REQUEST FOR INFORMATION **DATE:** December 01, 2016 **NO.:** RFI-367

Project Name: 15051-Webster University Interdisciplinary Science Building Project No.: 15051

Subject: Roof drain elevations - revised

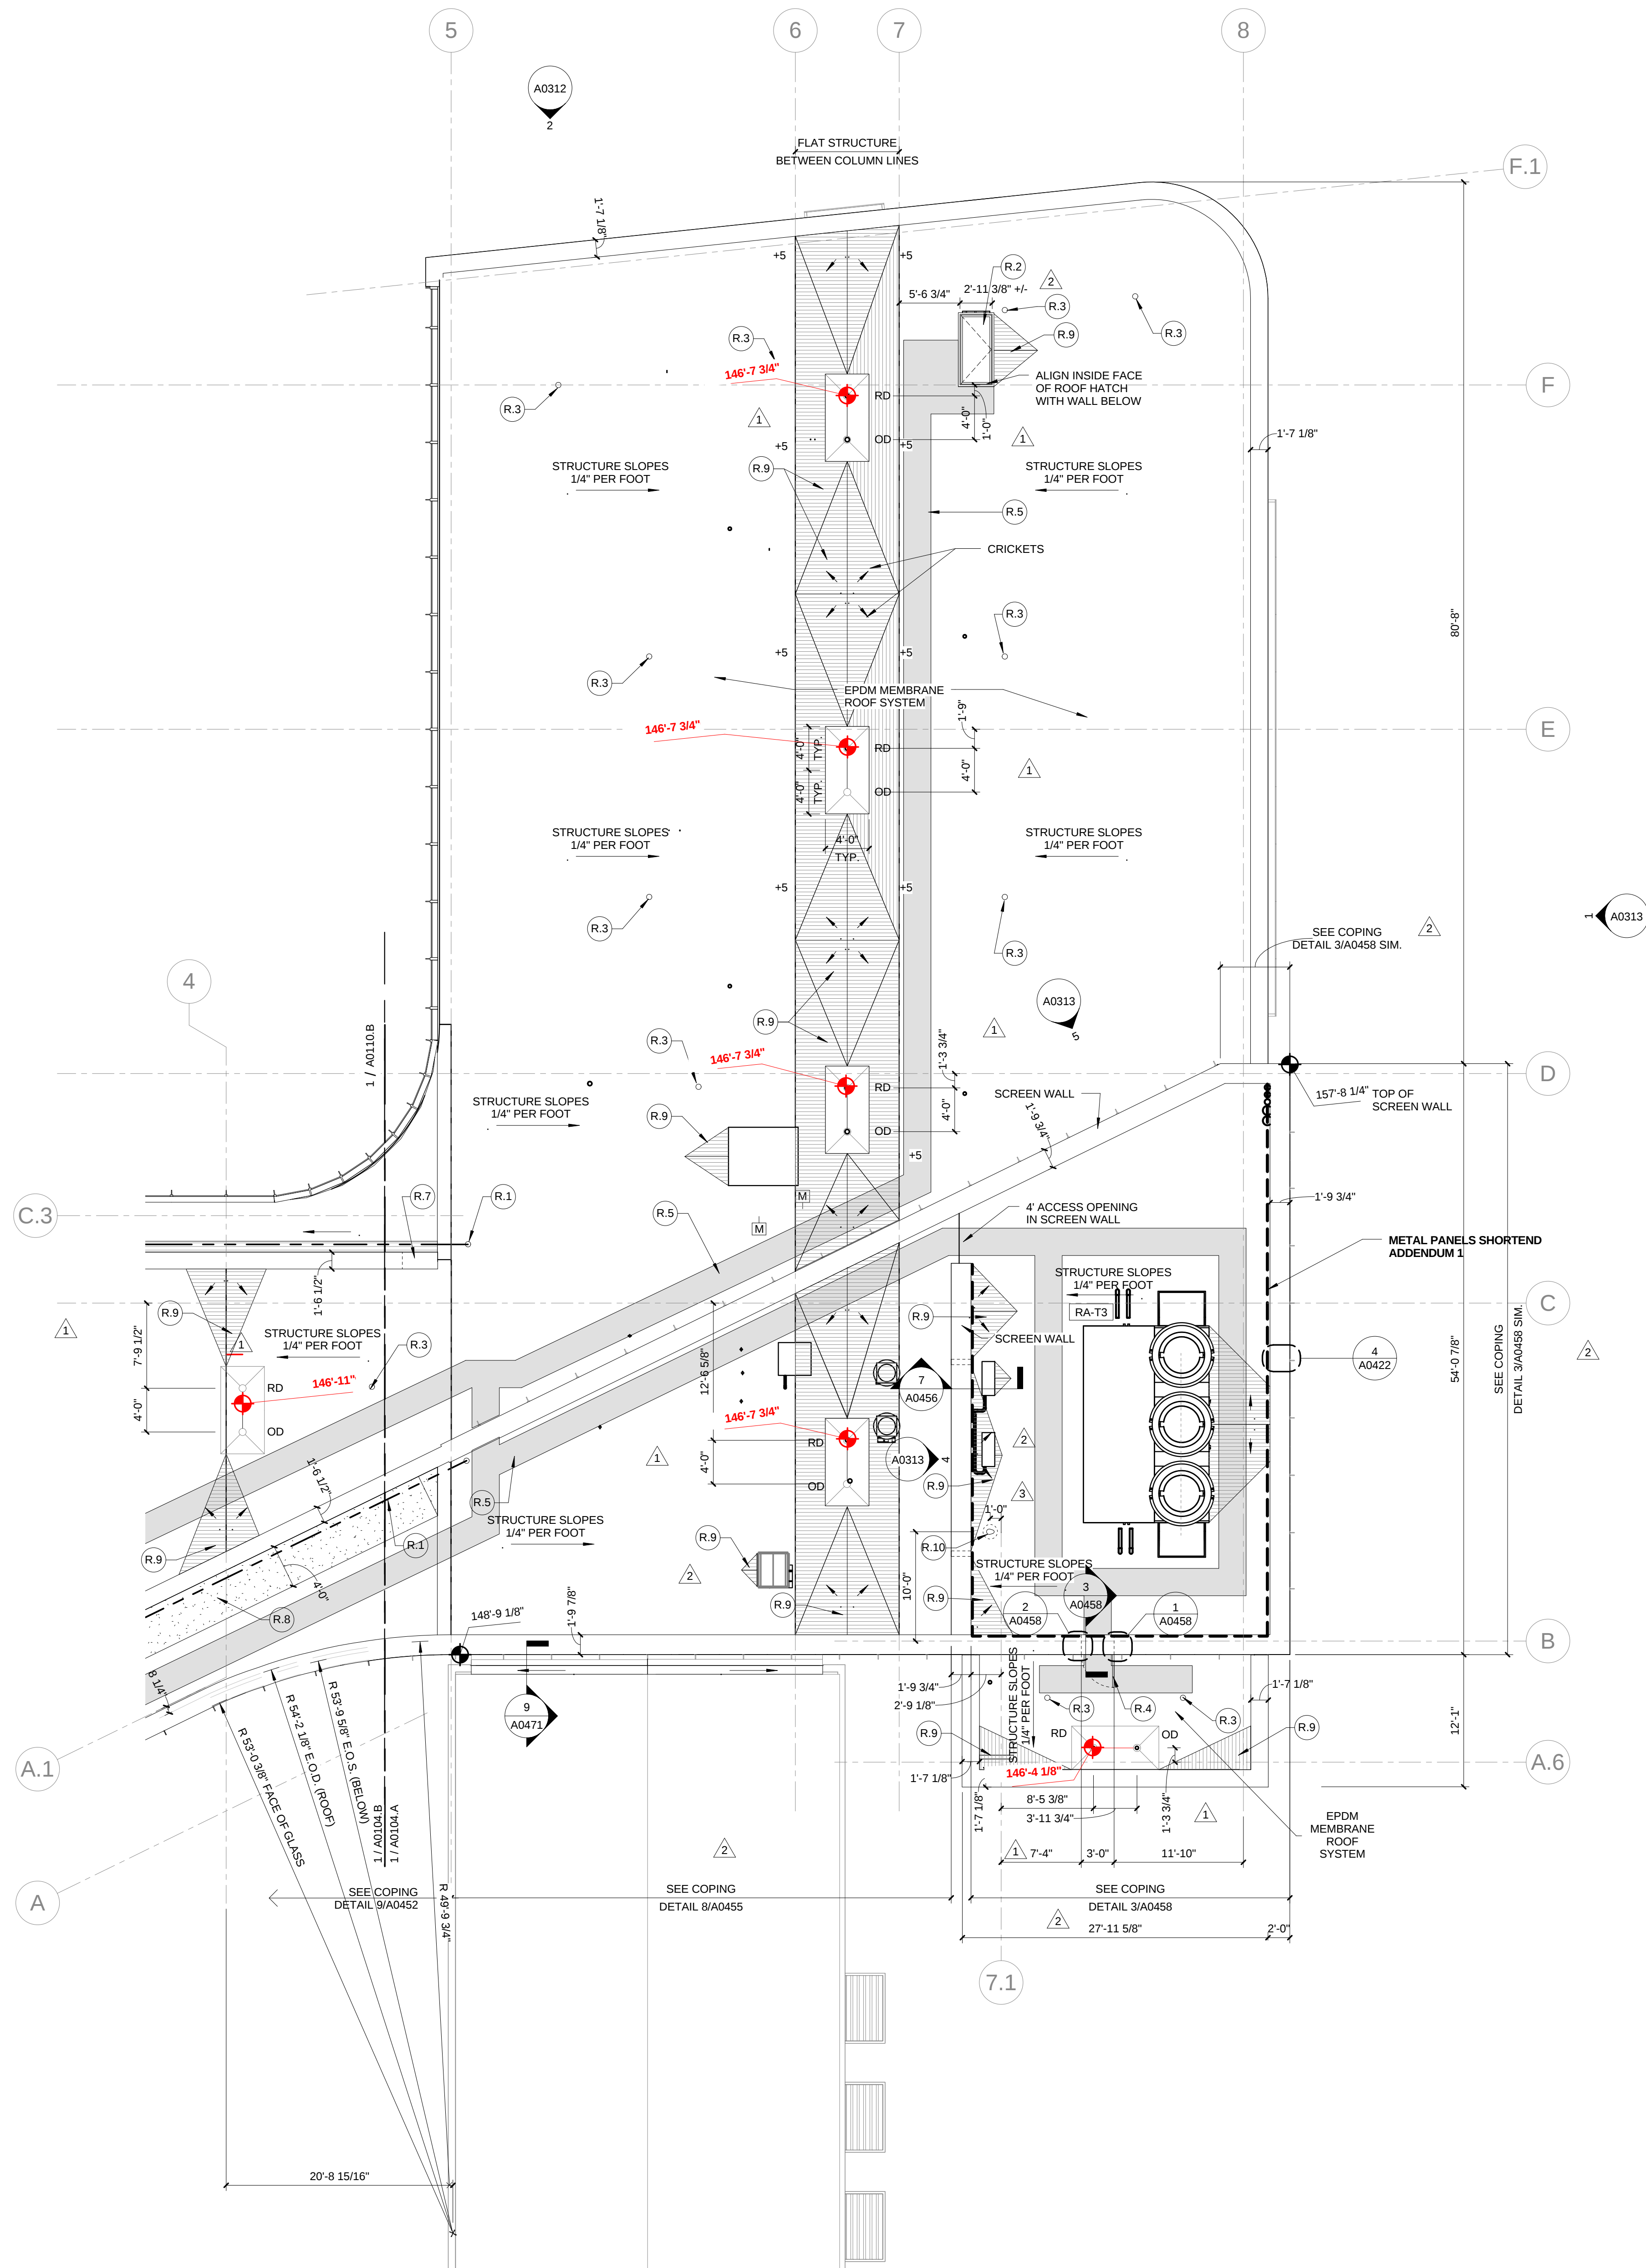
The roof and overflow drain elevations were given for the south paver drains on A0423 but not for the roof drains on the Architectural roof plans A0110.A and A0110.B. Please advise of the desired elevations.

Roof drains shall maintain a min of R-20 c.i. under the drain. The roof assembly is made up of thermal barrier (5/8"), insulation (3.5" min. to meet R-20c.i.) and coverboard (1/2"). A thickness of 4 5/8" at roof drains low point should be maintained. Overflow roof drains shall be installed so that the inlet is a min of 2" above the inlet of the main roof drain. Attached is a PDF showing spot elevations for drain elevations in red. Elevations are based on the Revit model. Contractor shall coordinate with existing conditions for any adjustments required.
